**DESIGN REVIEW BOARD MEETING  
PACKAGE**

*June 15, 2021 (Tuesday), 12:00pm  
Council Chambers, 2<sup>nd</sup> Floor, City Hall  
199 Queen Street  
Live Streaming: [www.charlottetown.ca/video](http://www.charlottetown.ca/video)*

**Design Review Board Agenda** (June 15, 2021) ..... (p.3)

EXTERIOR PROPOSAL  
FITZROY STREET MODULAR HOUSING

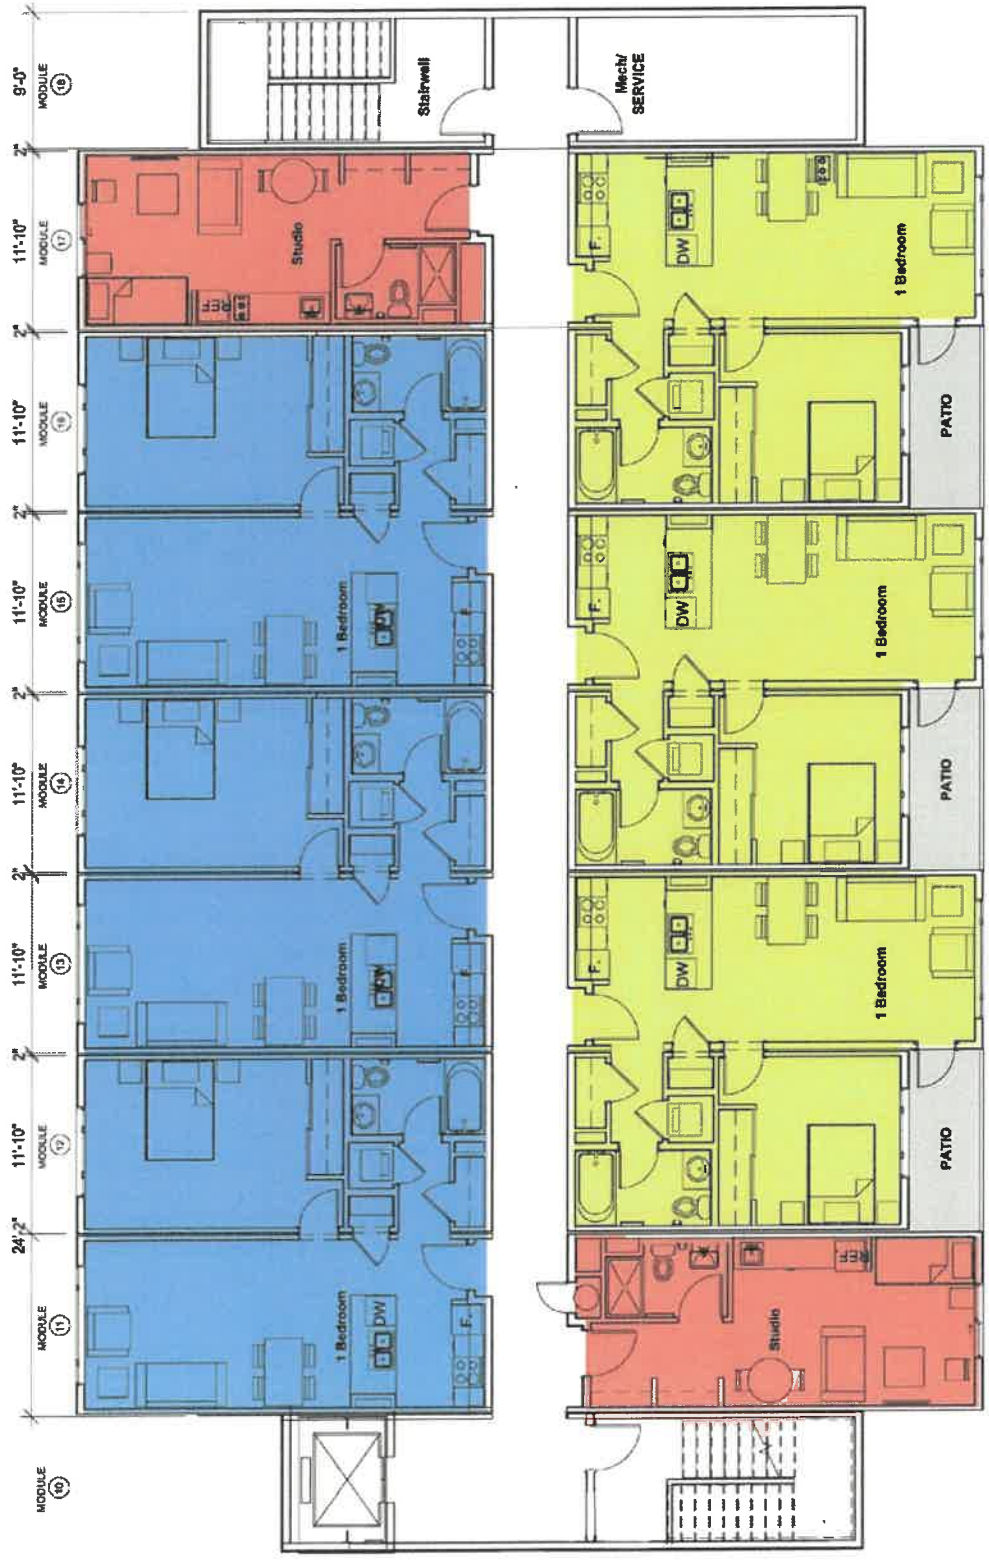
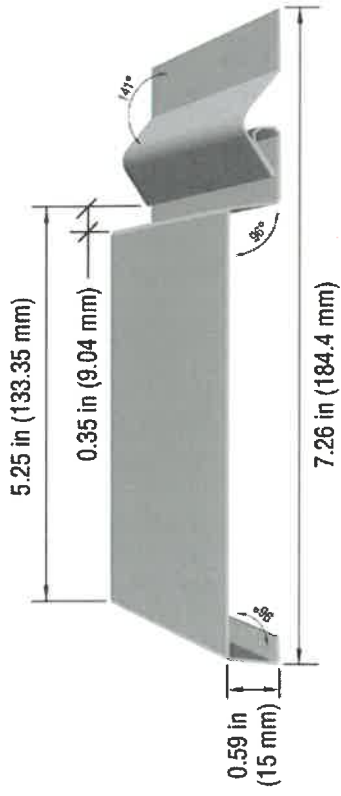
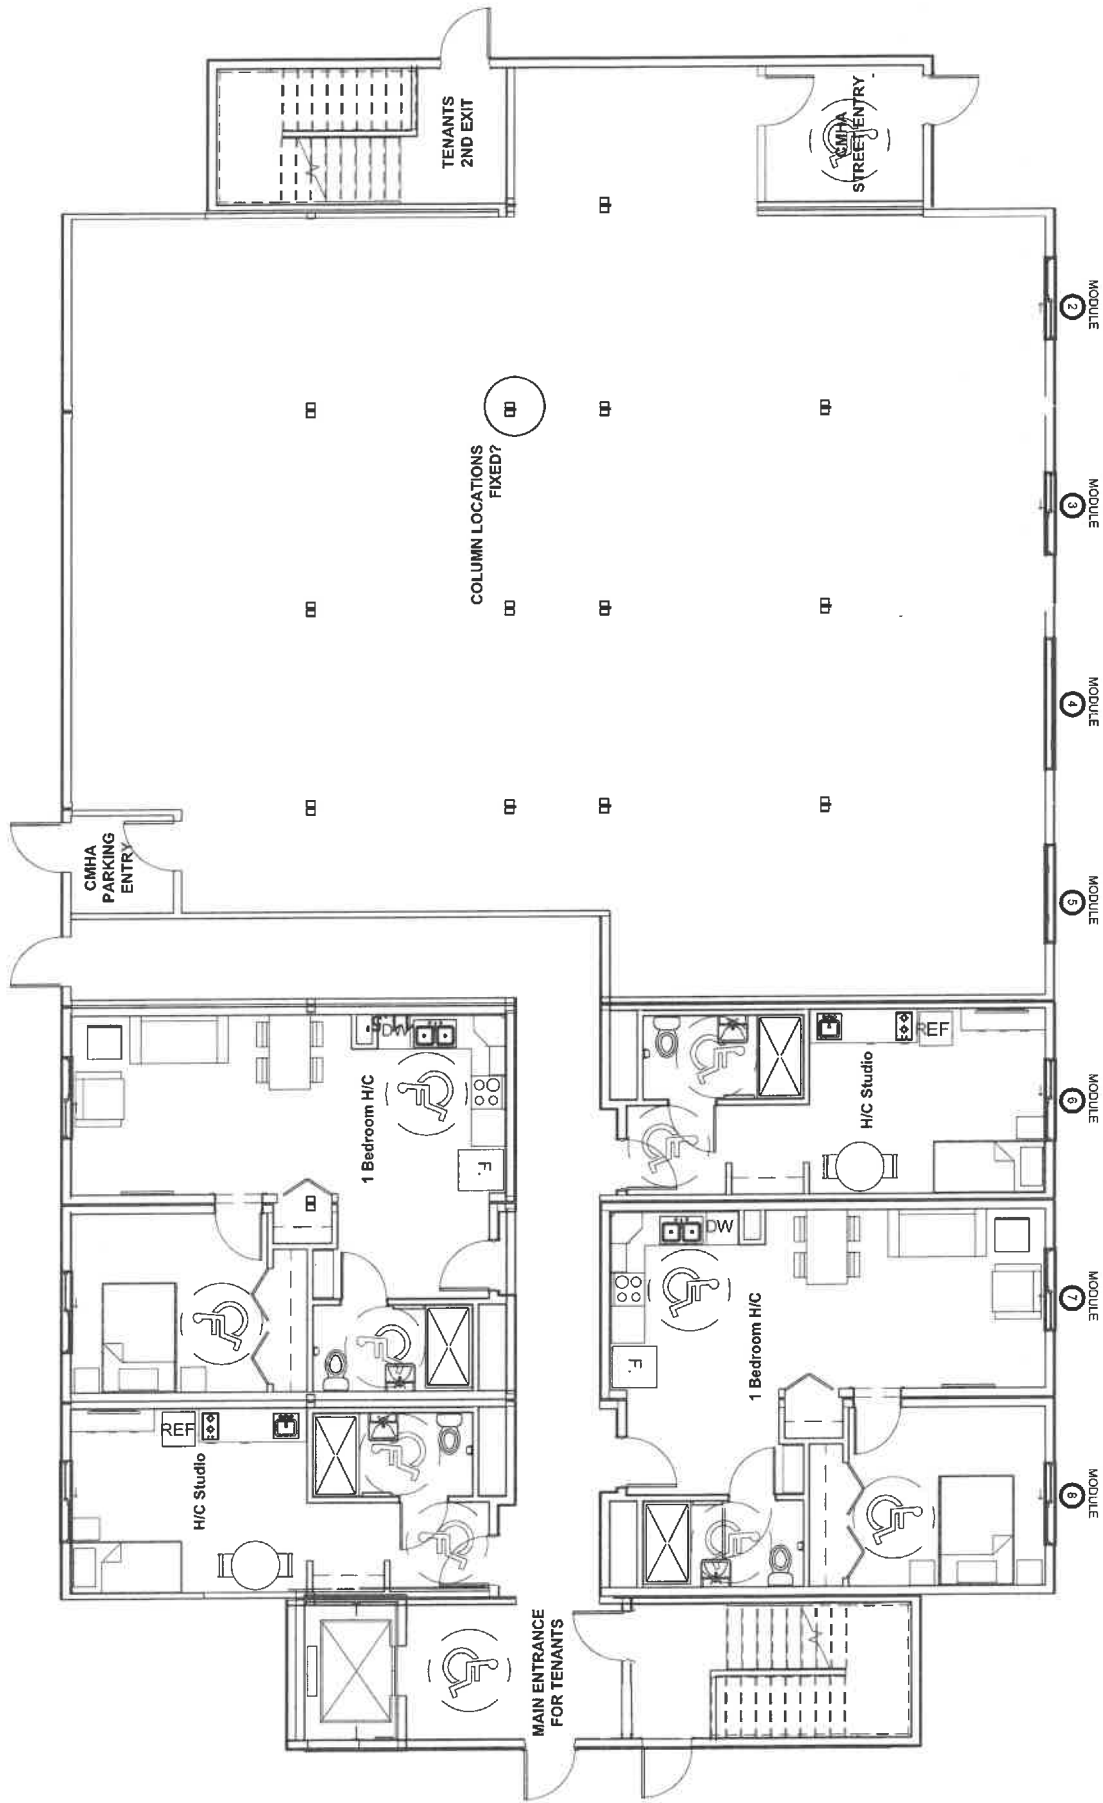
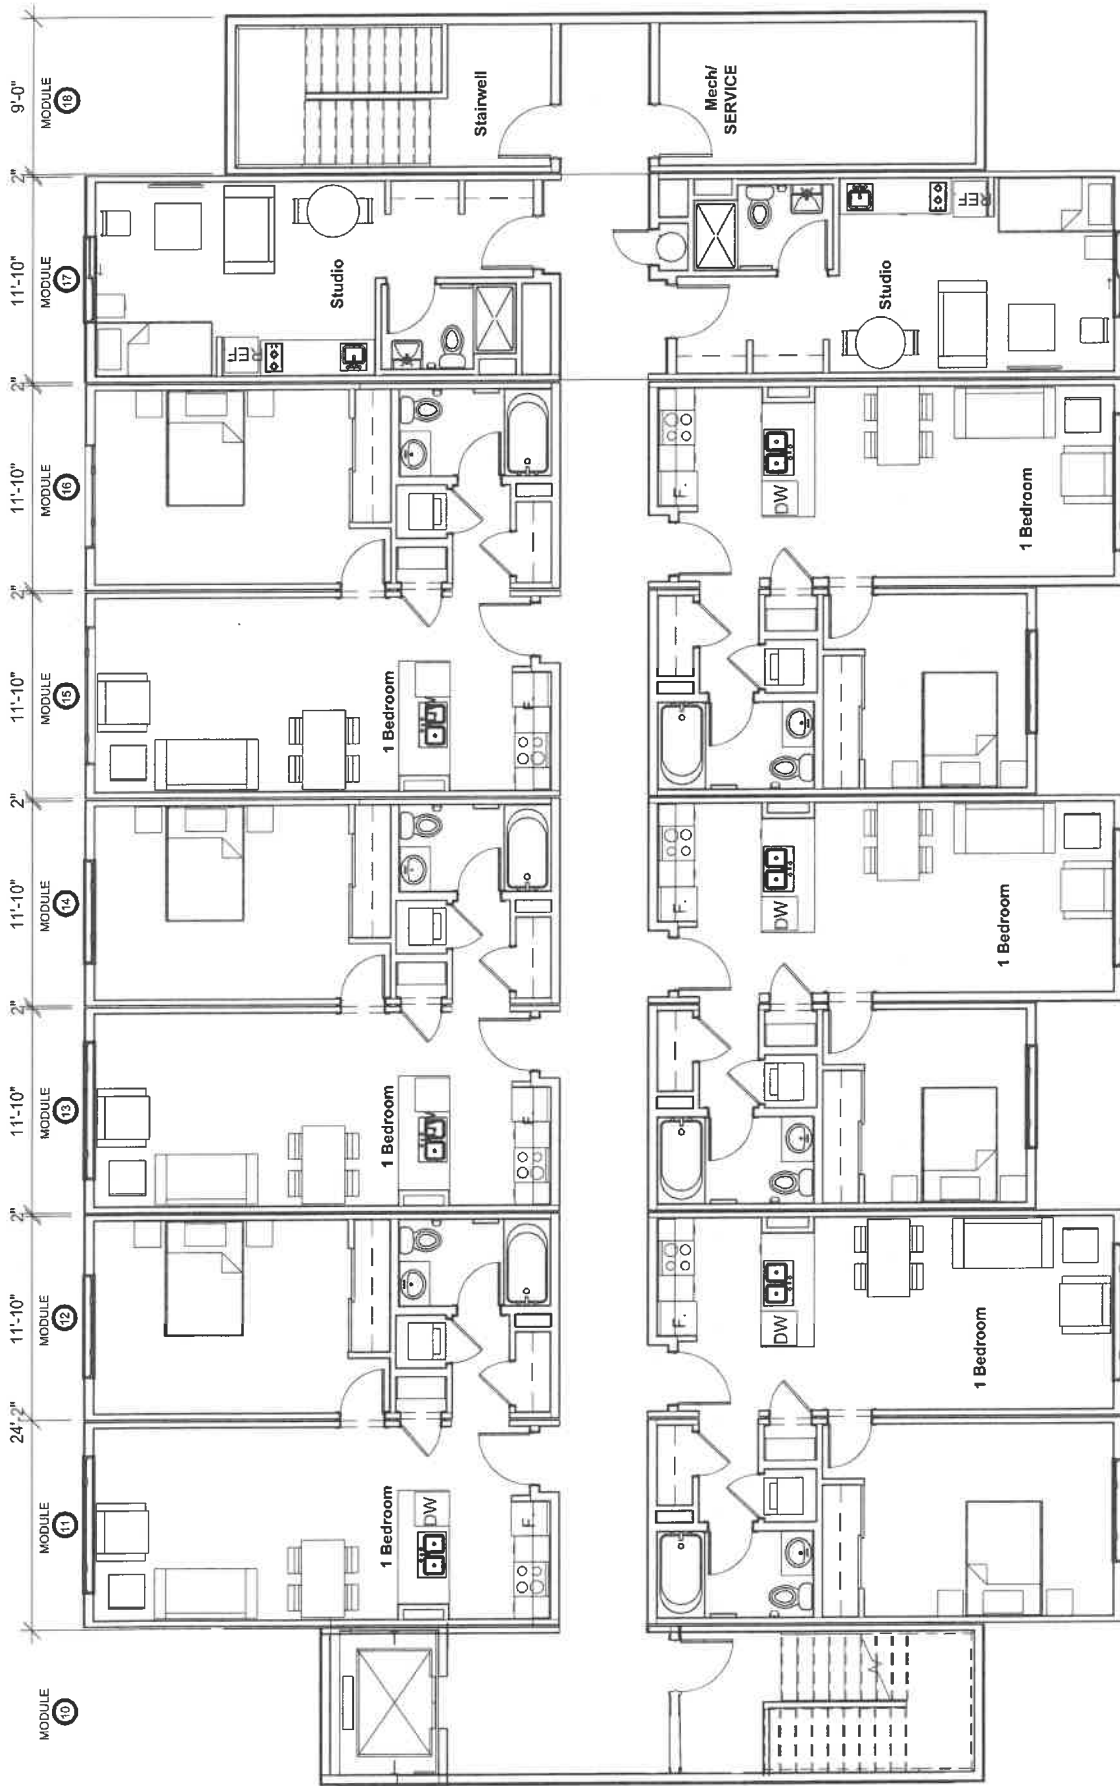
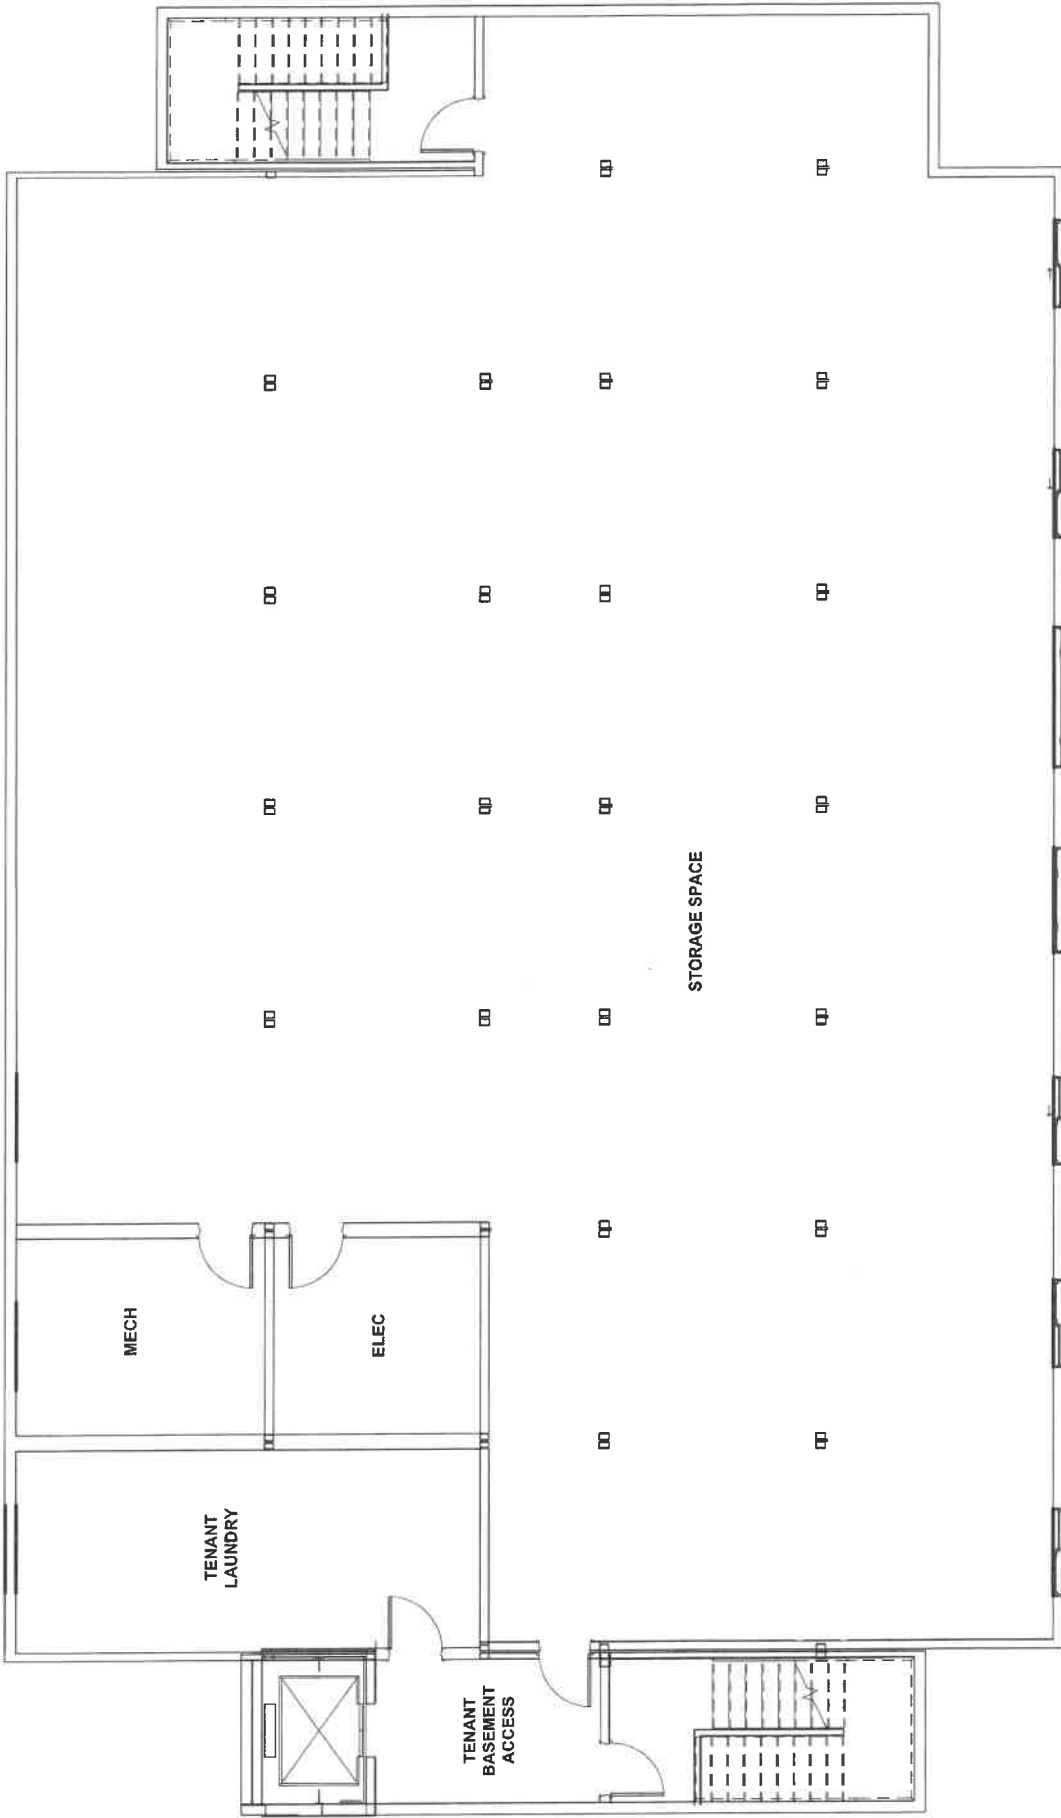
The proposed building is placed so that the building front aligns with the set back of the adjacent neighbours. There is a single vehicular access on the east side adjacent to the laundromat and which terminates in a parking lot at the rear of the site. The site plan does not indicate any landscaping details, but it does provide open space of 30 - 40 feet between the building and the parking. This provides a nice buffer and with attention to landscape detail and design, would provide nice opportunities for the tenants to enjoy an outdoor amenity space. The plans do not indicate how the garbage will be handled or where the snow will be stored.

From a building access perspective, the office entrances are readily identifiable from the street, but the residential is not so well defined and as mentioned above, has an unhappy relationship to the sidewalk and drive aisle. In fact, it looks like there is a grade change there and with the entrance door swinging out, making it dangerous and problematic. Is there a better solution to the lobby/exit stair design to avoid an entrance door and exterior stairwell exit door adjacent to each other? Both the rear [parking lot] entrances are weak as well. It is difficult to tell from the renders, but it looks like there are canopies proposed over the entrances. I am in favour of protection from the weather and the contribution to more clearly defining the entrances by incorporating them.

1. Introduce soft and hard landscaping features.
2. Create exterior amenity spaces.
3. Revisit the apartment building main entrance. Both to define the entrances and provide shelter.
4. Consider canopies.
5. Revisit the entrances facing the parking lot.
6. The colours are in vogue now but is there a different more timeless palette?
7. Revisit the relationship of the apartment main entrance to the drive aisle.
8. Provide details on garbage storage and snow storage.

- Three of four entrances have canopies. Nine Yards will further detail these features during the preparation of construction drawings.
- Nine Yards ability to modify the residential entrance is limited due to the modular nature of the building, however Nine Yards agrees with Mr. Matthews comments and will increase the proposed separation distance between the driveway and residential entrance.

## 2.5 Elevations

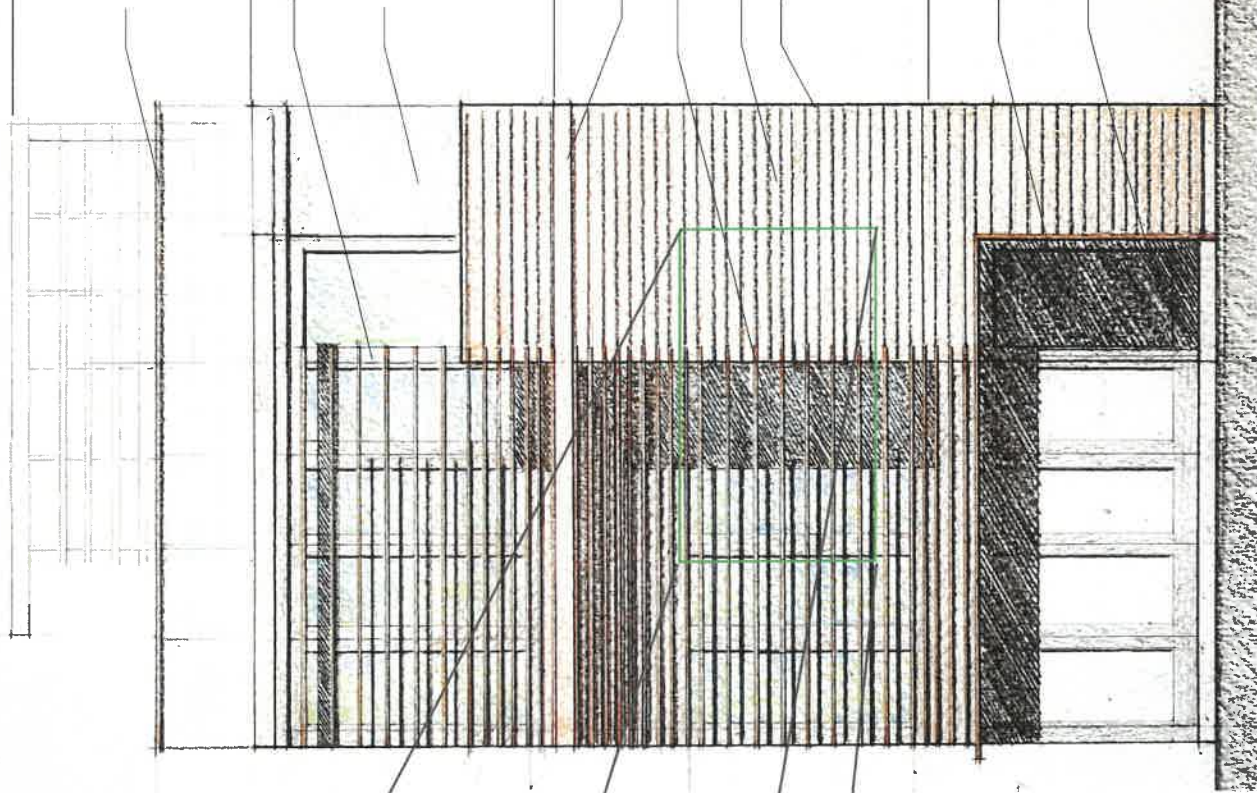
1. Several minor discrepancies were noted between the floor plans and the elevations presented in the applicant's submission, such as an indication of a shower on the third floor plan projecting past the plane of the setback façade, whereas the elevation does not illustrate this volume. Based on our conversation with the applicant, it is assumed for the purposes of this review that the elevations presented in their submission are correct.

As shown on page 22 of the applicant's submission, the rooftop occupancy begins at a height extending above the neighbouring context and it is assumed from the elevations that the proposed rooftop deck railing sits in the same plane as the primary building façade. Given this, the materiality and transparency of the railing must be reviewed so as to not read as though the building façade is higher than what relates to the size and scale of the neighbourhood. Although the proposed façade design steps back to acknowledge the neighbours, it must be recognized that the roof planes of the historic buildings on the street step back from the street at a much greater rate and, therefore, the proposed townhouses already have an increased street presence at the third floor line.

- 3.1. The rooftop railing material must have a high degree of transparency, such as glass or thin metal wire or similar materials.
- 3.2. Alternately, the rooftop railing must be sufficiently set back from the façade so as to not be visible from the sidewalk on the opposing side of the street.
4. The applicant has provided little analysis of the rooftop stair enclosure in their submission, however, its appearance from the street and from various view planes may have an effect on the developments perceived bulk in relation to the surrounding context. Of particular interest is the end unit closest to Pownal Street where the side yard façade could have an appearance of being 4 storeys tall and well above the adjacent property.

### 3.3 Parking Access & Garages

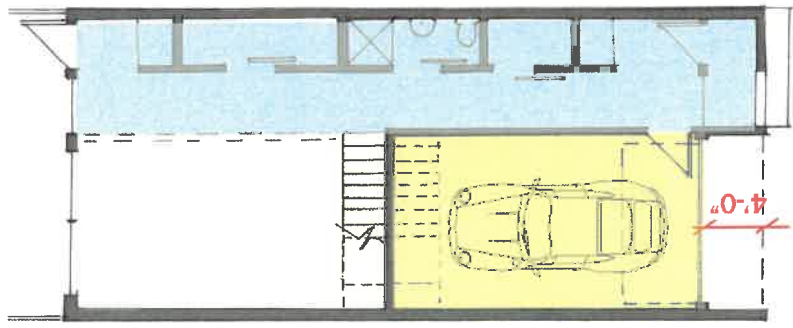
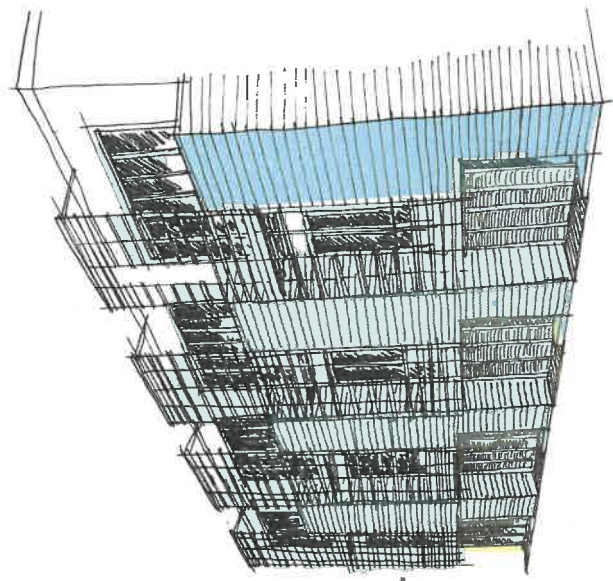
- 7.1. Supplementary design and material information must be provided by the applicant and be agreed to in advance of the issuance of building permits to give a clear understanding of the proposed garage design.
  - 7.2. The garage door materials must be of the highest quality and it is essential that the design provide visual interest to animate the street-level façade.
8. Building on comment #7 above, the presence of multiple driveways at the street front in close succession requires frequent interruption of the sidewalk. This serves to interrupt the pedestrian experience, provides difficulties for those with visual or mobility impairments, and can cause safety issues with cars crossing the path of pedestrians, particularly when blindly backing out of garages with very short driveways such as that proposed by the applicant.

- 8.1. Where possible, driveways should be grouped and shared to minimize the number interruptions to the sidewalk.
  - 8.2. To give priority and added safety to the pedestrians by slowing vehicular approaches, each driveway should ramp upward to meet the sidewalk elevation rather than drop the sidewalk to meet the street elevation.
9. During our discussion with the applicant regarding the front stoop design, it was indicated that some revisions to the plans have been made since the initial submission and that the elevations provided may not fully represent those changes. Some concerns with the presented design were raised regarding the potential for dark corners, crime prevention strategies, garbage collection, garbage storage, and reduced visibility and connection of the entrance from the street.
